Item Name: Crosstube Turning Detail

DART AEROSPACE LTD		Work Order: 132287
Description: Crosstube Assembly (206L High Fwd)		Part Number: D206-667-143
Inspection Dwg: D206-667-143 Rev: C		Page 1 of 2

DRAWING NO. D206-667-143	TITLE CROSSTUBE ASS'Y. (206L HIGH FWD)	REV. C	DART AEROSPACE LTD ENGINEERING ORDER		D.E.O. NO. D206-667-143-C-1	SHEET NO. SHEET 1 OF 1	SCALE NTS
DRAWN 42	CHECKED ASS	MFG. APPR. [Signature]	APPROVED [Signature]		DE APPR. [Signature]		
DATE 11.07.15	DATE 11.07.20	DATE 11.07.21	DATE 11/07/21		DATE 11.07.21

DRAWING NO. D206-667-143		TITLE CROSSTUBE ASS'Y (206L HIGH FWD)		REV. C	DART AEROSPACE LTD ENGINEERING ORDER		D.E.O. NO. D206-667-143-C-2		SHEET NO. SHEET 1 OF 1		SCALE NTS
DRAWN AJS		CHECKED		MFG. APPR.		APPROVED		DE APPR.			
DATE 12.08.02		DATE 12.08.02		DATE 12.08.02		DATE 12.08.02		DATE 12-08-02

DETAIL P
BONDING STRAP INSTALLATION 2 PL

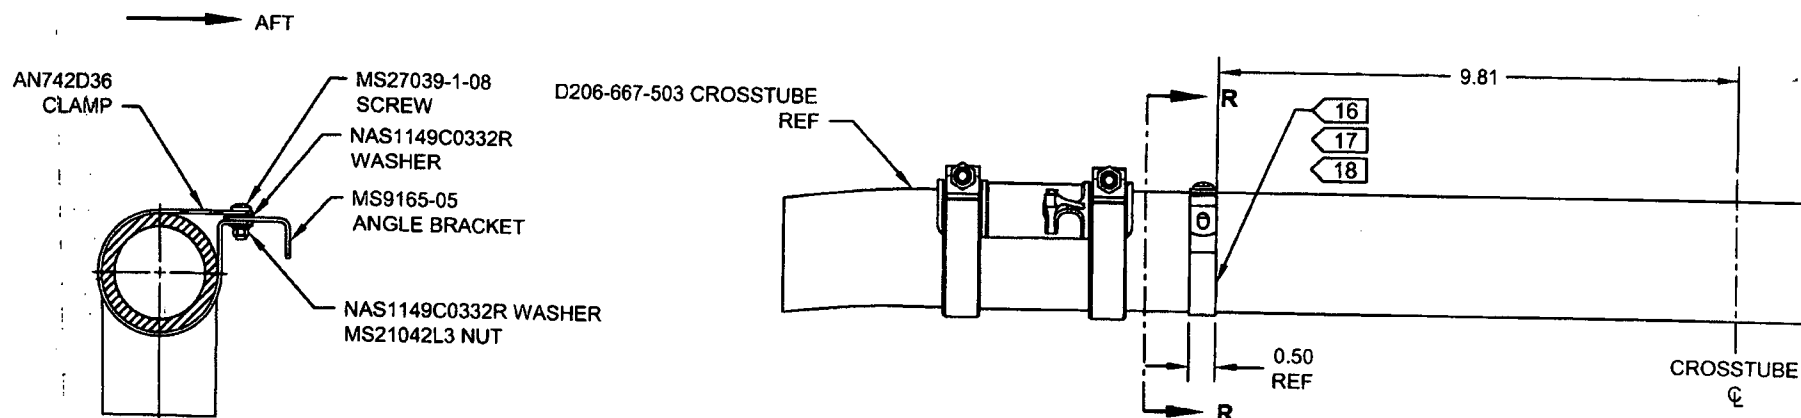
PURPOSE:

ADD ELECTRICAL GROUNDING STRAP

ADD

- 16) MASK AREA UNDER CLAMP PRIOR TO PAINTING
- 17) SEAL EDGES WHERE AN742D36 CLAMP MEETS WITH THE CROSSTUBE USING SIKAFLEX-241/-291 OR MIL-S-8802 CLASS B2 OR PROSEAL 890 SEALANT
- 18) PERFORM RESISTANCE CHECK TO ENSURE MAX RESISTANCE IS 10 MILLIOHMS
